**Review of Hydrology/Water Resources Portions of the Draft Environmental Impact Review  
Idaho-Maryland Mine, SCH No. 2007092017**

January 14, 2009

Tom Myers, Ph.D.  
Hydrologic Consultant  
Reno, NV

**Figure 1: Radius of influence using the equation and assumed hydraulic properties from Todd Engineers (2007). The graph shows clearly that the radius of influence depends on the number of days assumed for steady flow to occur.**

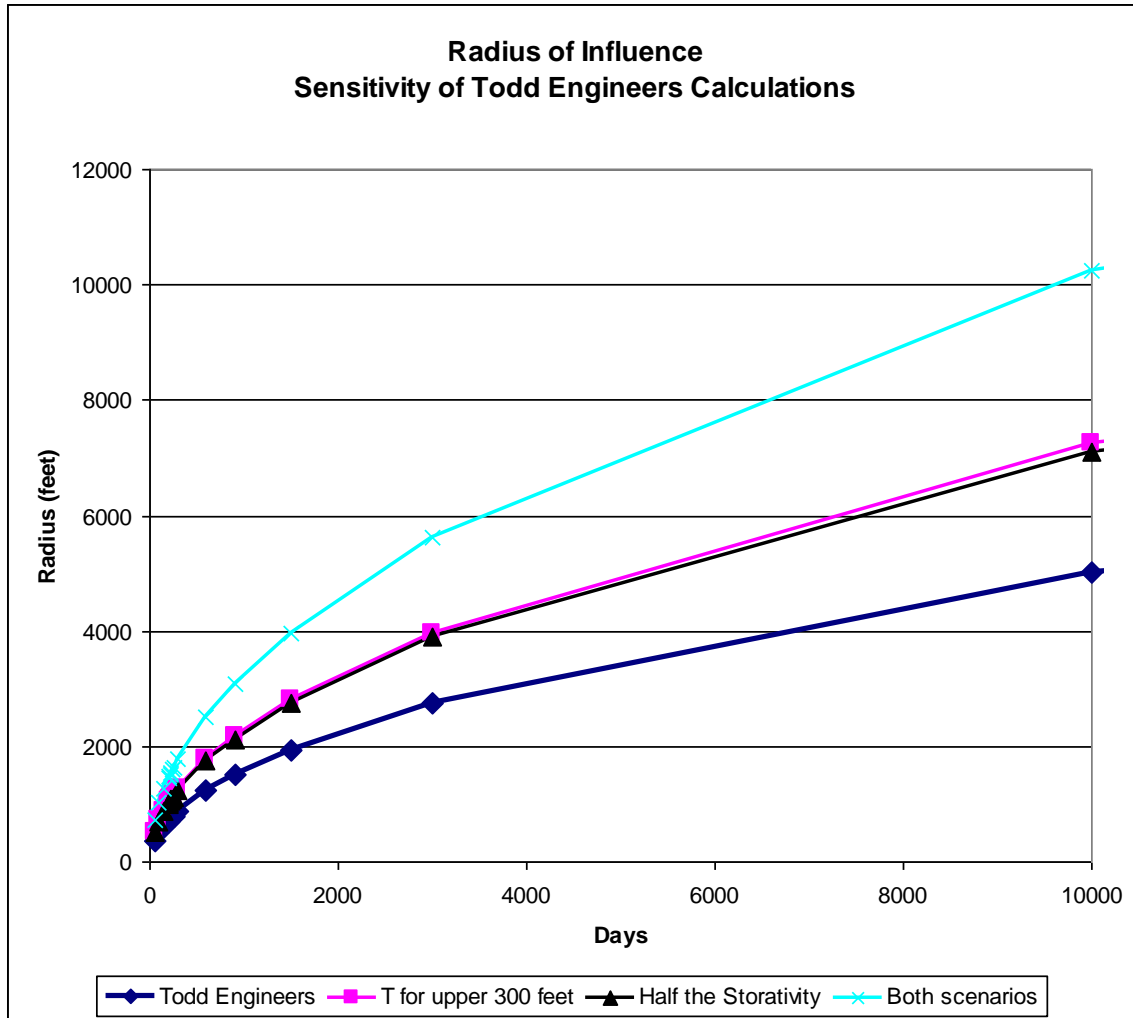
They predicted the radius of influence equals 710 feet with steady flow occurring after 200 days. Their most troubling assumption is that steady flow conditions occur after 200 days, the amount of time estimated to pump the entire 532,000,000 gallons out the shaft into Wolf Creek. They base the estimate on a previous estimate that 850 gpm will be the flow rate into the shaft once it is dewatered and assume that rate will occur by the time the shaft is emptied (Todd Engineers, 2007, page 21).

The 200-day assumption is critical. The radius of influence as determined with their equation becomes larger with time; if the time to equilibrium exceeds 200 days, the radius of influence would be much larger. The DEIR acknowledges that the 200-day estimate is a major assumption, and calculates the additional radius of influence that would result if steady flow did not occur for two years (DEIR, page 4.7-33); it would be about 620 feet further from the mine. However, this was another guess. After 10,000 days, approximately the length of the project, the radius of influence is closer to 5000 feet (Figure 1).

As a way to justify their 200-day assumption, Todd Engineers state that if the drawdown were to continue to expand, it would bump against natural boundaries. These boundaries would be faults, which have not been shown to actually be boundaries. The DEIR acknowledges that this is just an assumption and that the faults may actually be conduits for flow (but does not refute the idea that the faults will limit the effect) (DEIR, page 4.7-33). The DEIR considers that the Weimar fault may act as a conduit to expand the potential drawdown along the fault (*Id.*).

It is therefore essential that Todd Engineers provide a better justification for their radius of influence analysis.
